Message Ref: Amberfield project – Hamilton City Council s92 response. Terrestrial ecology.

Project No: A17134

Below is a response to the s92 further information request from Hamilton City Council (HCC) regarding terrestrial ecology. Each response is numbered following the HCC s92 Master Schedule – Category 1 document.

EARTHWORKS CUT / FILL PLAN
SHEET 1 OF 6

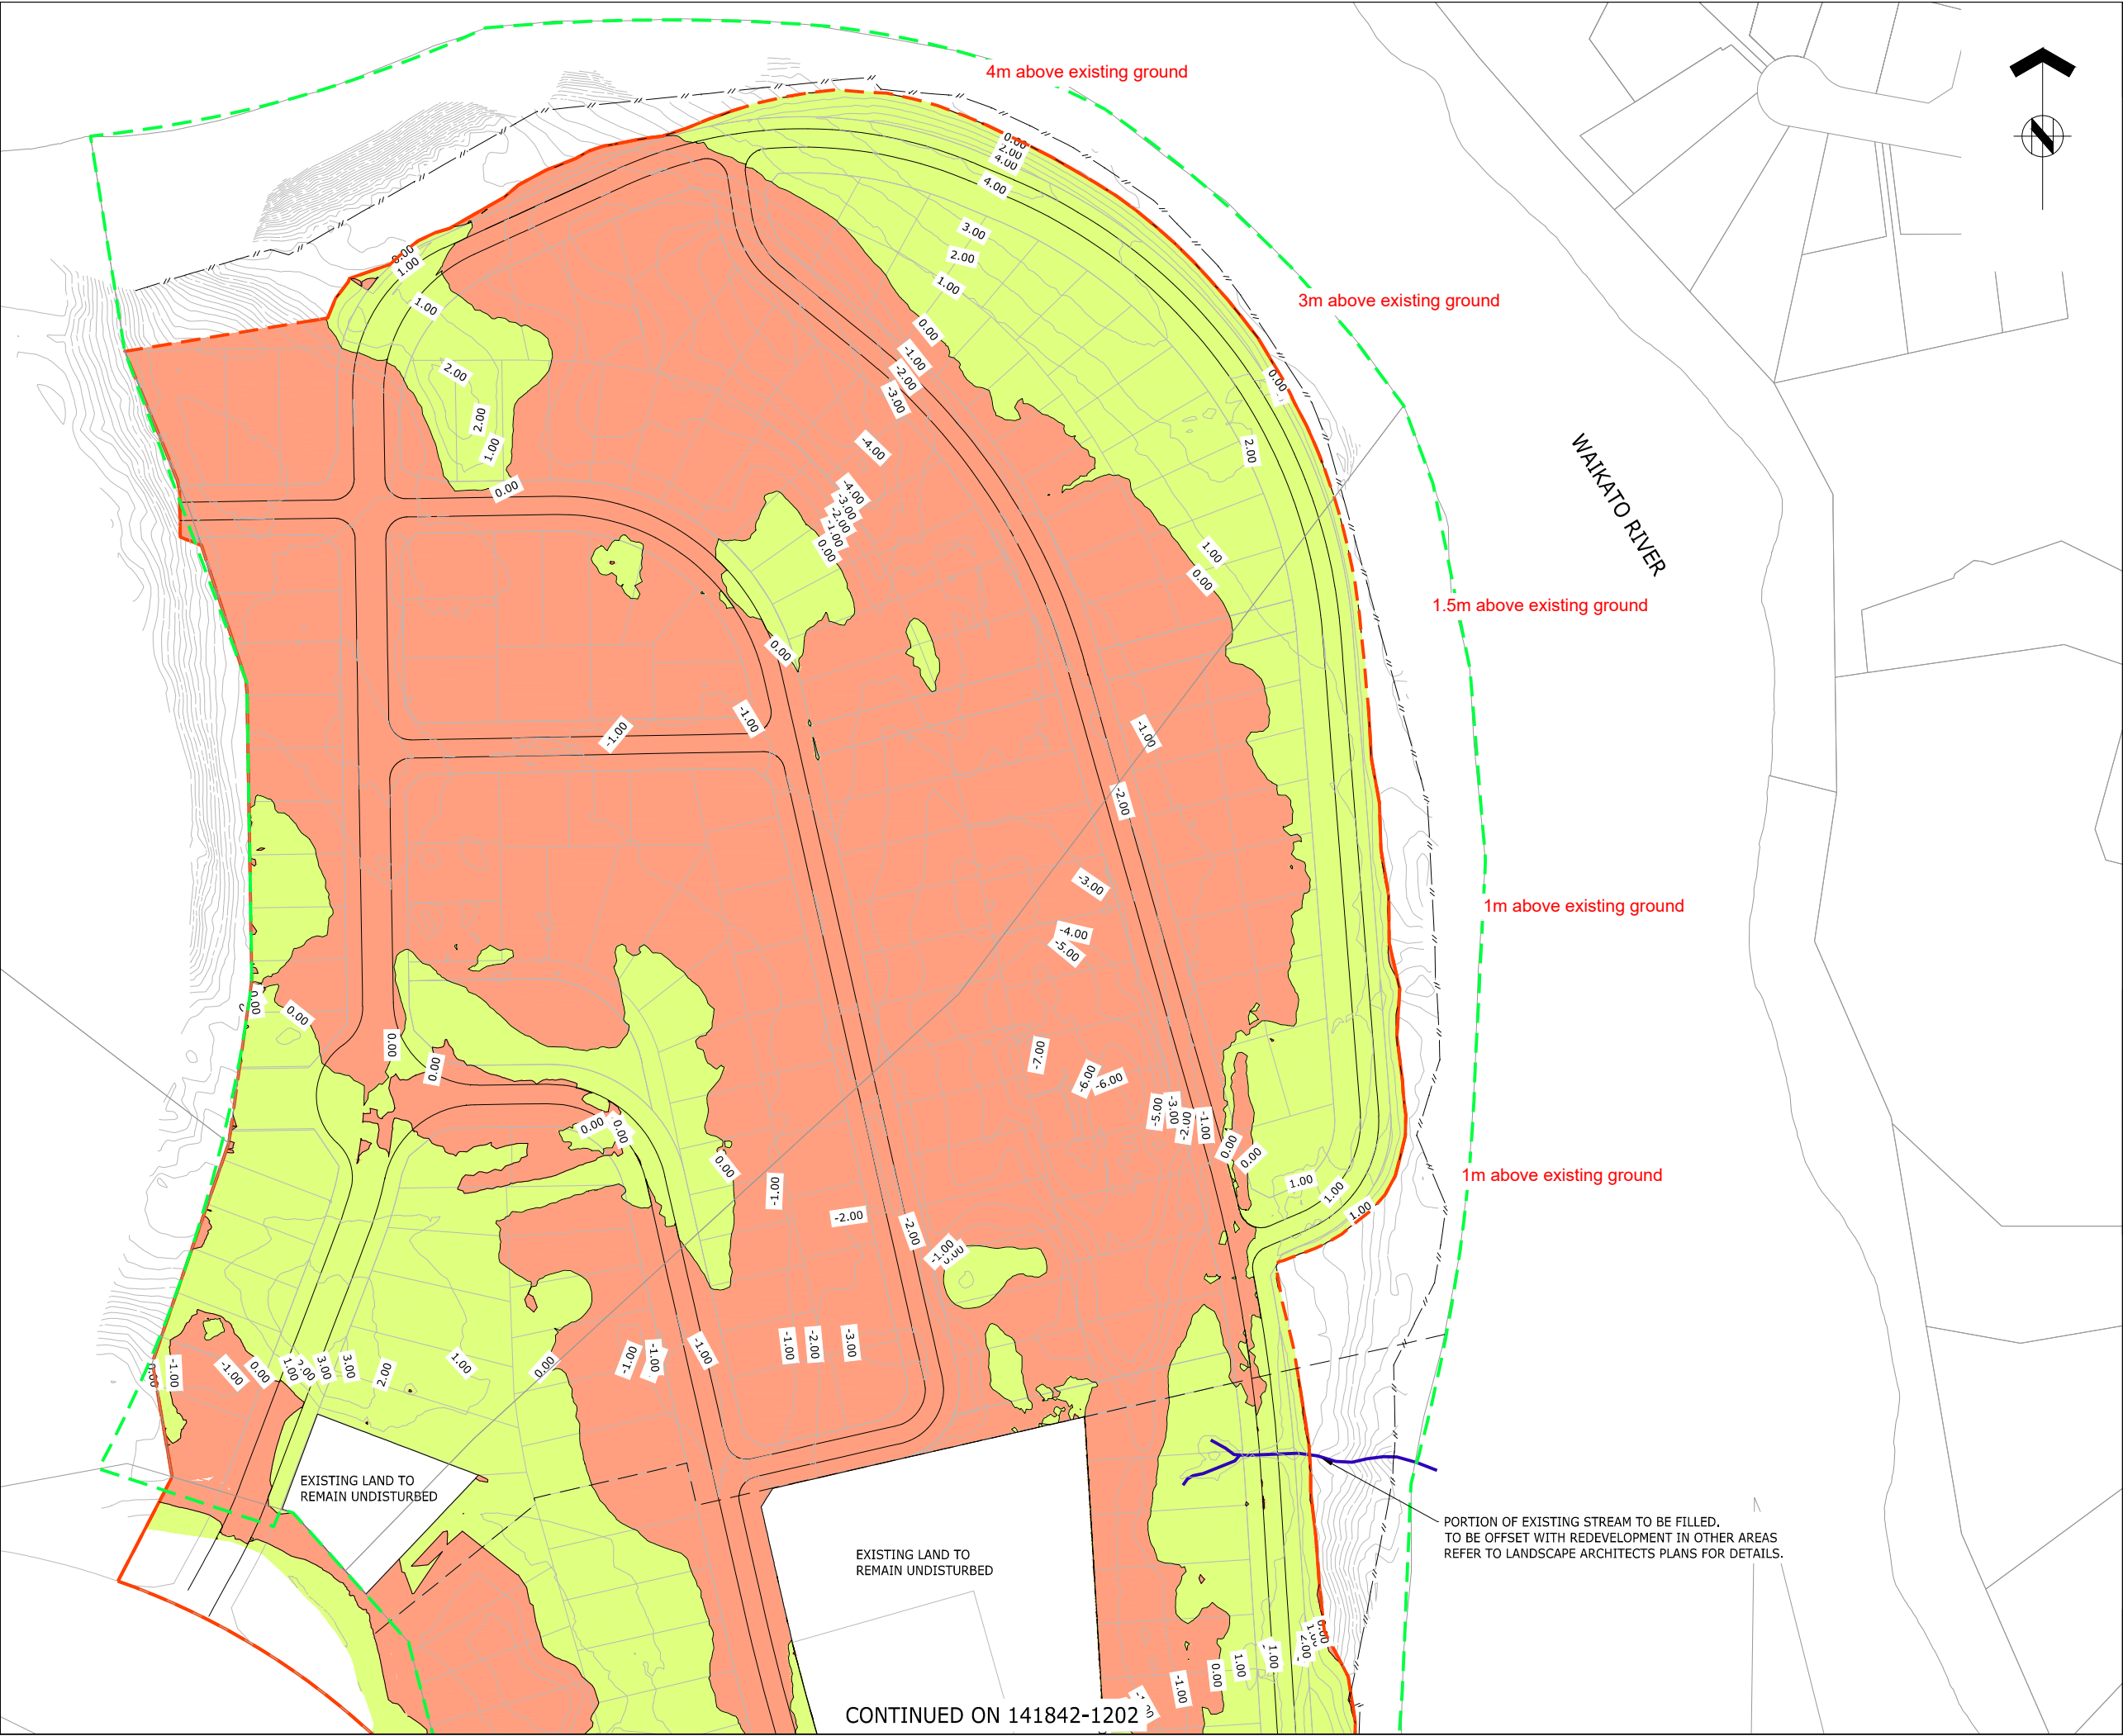
The project ecologists have considered this point and have worked with the engineers for the project to address the limited buffer planting. The significant constraint for buffer planting in the northern end of the site is the height of the road above the existing ground level and therefore the existing vegetation or any planted additional buffering vegetation at existing ground level (refer to Appendix 5) will be of less benefit compared to planting at road level. In response to this, a further site assessment has been undertaken to confirm the existing vegetation’s location with regards to the existing fence and proposed toe of the batter slope.

The onsite assessment found that there is enough space to extend the toe of the batter slope a minimum of 6 metres closer to the top of the river bank as there is room behind the existing fence before the existing riverbank vegetation or river bank is impacted (Figure 1). Moving the toe of the batter slope closer to the river will allow a minimum³ 7m wide planting strip, elevated at road level, on the river side of the road (Refer to Appendix 6 & 7 - this additional 6m is attached to the 1m wide berm indicated on the river side of the shared path). The planting strip will be able to be planted with several layers of tall structure evergreen vegetation and under planted with dense shrubs to buffer the lighting and noise from the adjacent road and housing. This pushing out of the toe of the batter slope to allow for this additional planting zone may require removal of several exotic trees which are located of the farm side of the existing fence; these trees do not contain any potential roost features and are of negligible ecological value. The removal of these individual trees is more than mitigated by the ability to provide a 7m wide strip of buffering and planting elevated at the road level to more effectively block light than the established trees could. We consider that this approach will significantly reduce the light spill from the development in this area over the Waikato river and into the adjacent sensitive bat habitats and will contribute to a far greater avoidance of potential offsite impacts of the development.

■ ■ ■ TYPICAL LOCAL PARK EDGE ROAD
(TYPE E MODIFIED)

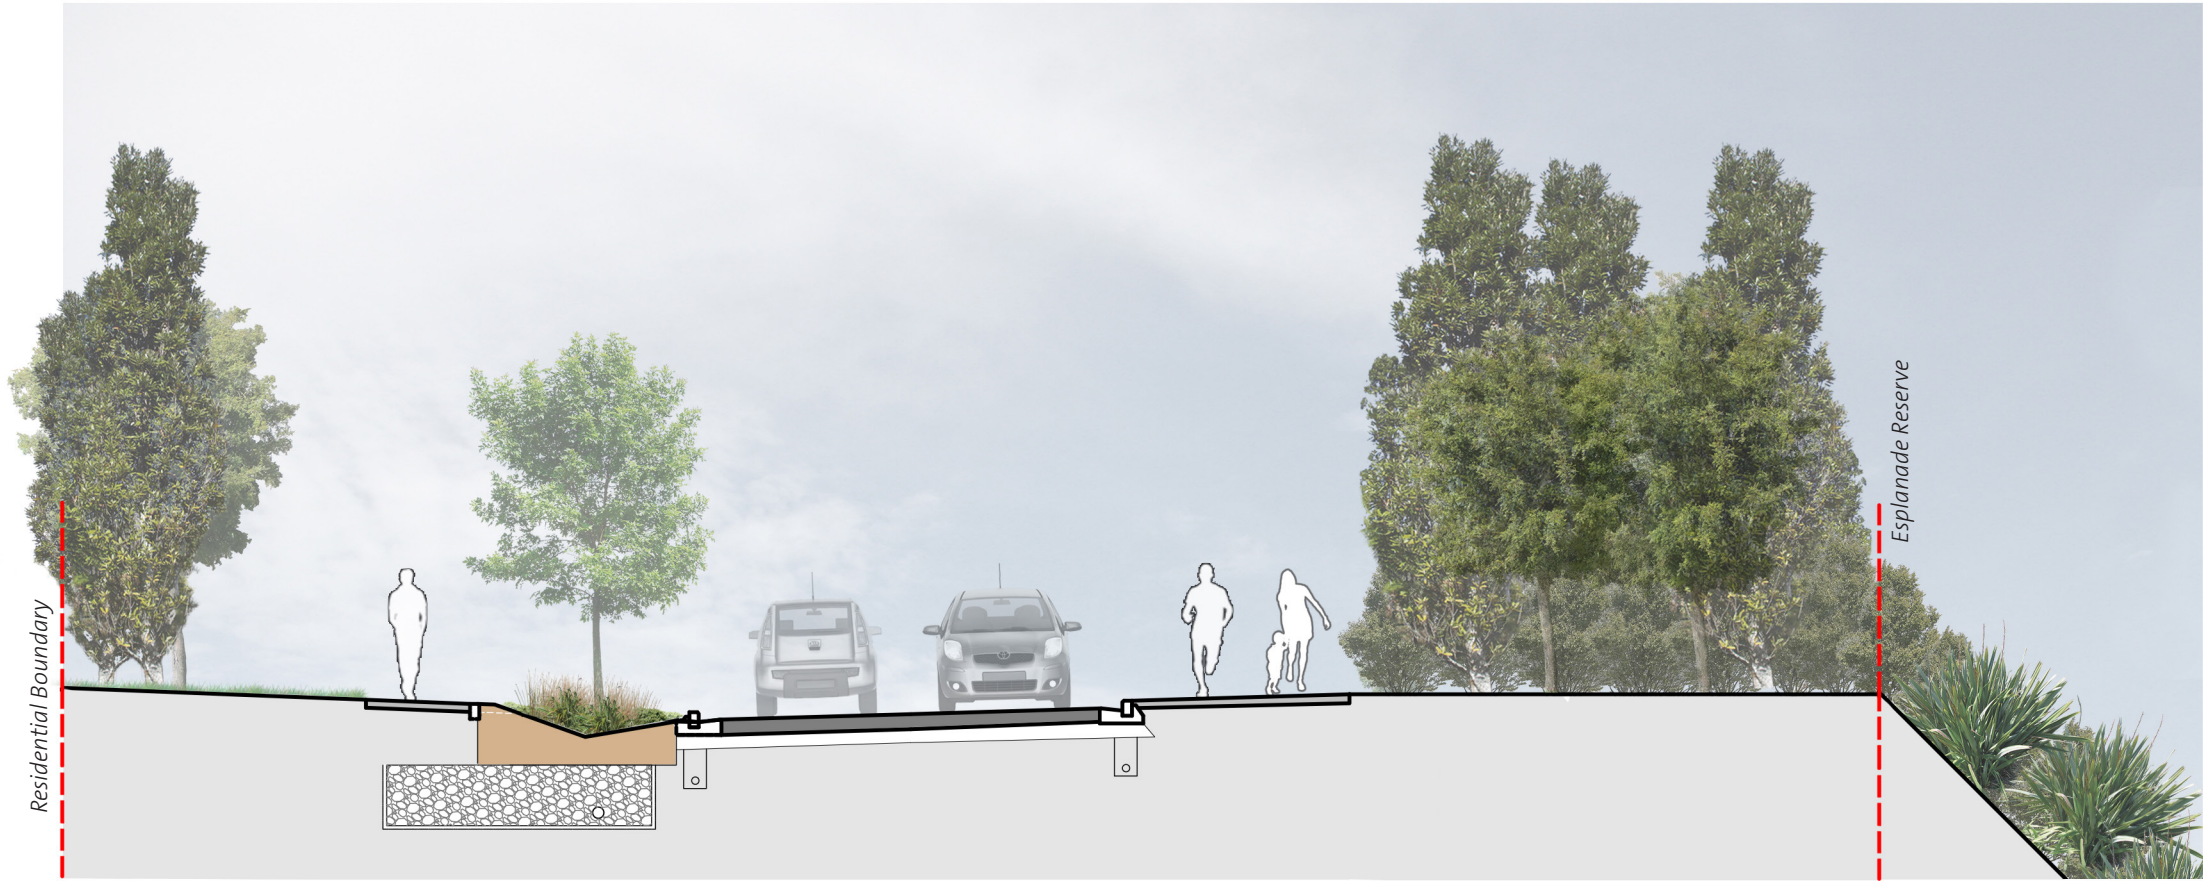
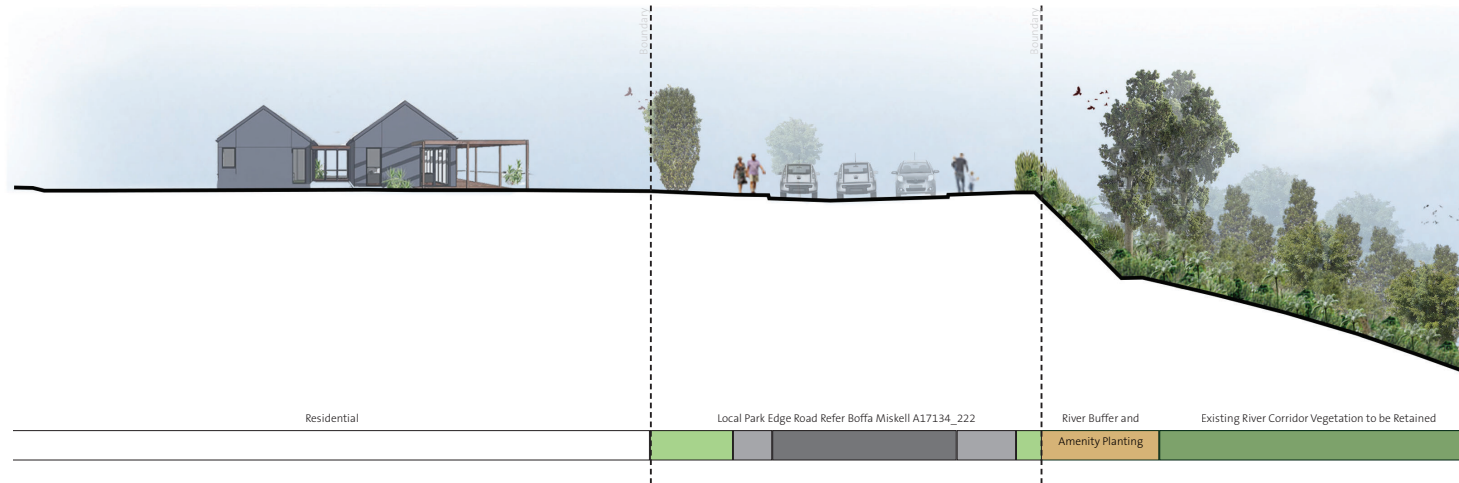
Cross section relates to northern Park Edge Road where wider berm width is provided to achieve additional light / noise screening for bat migration and habitat
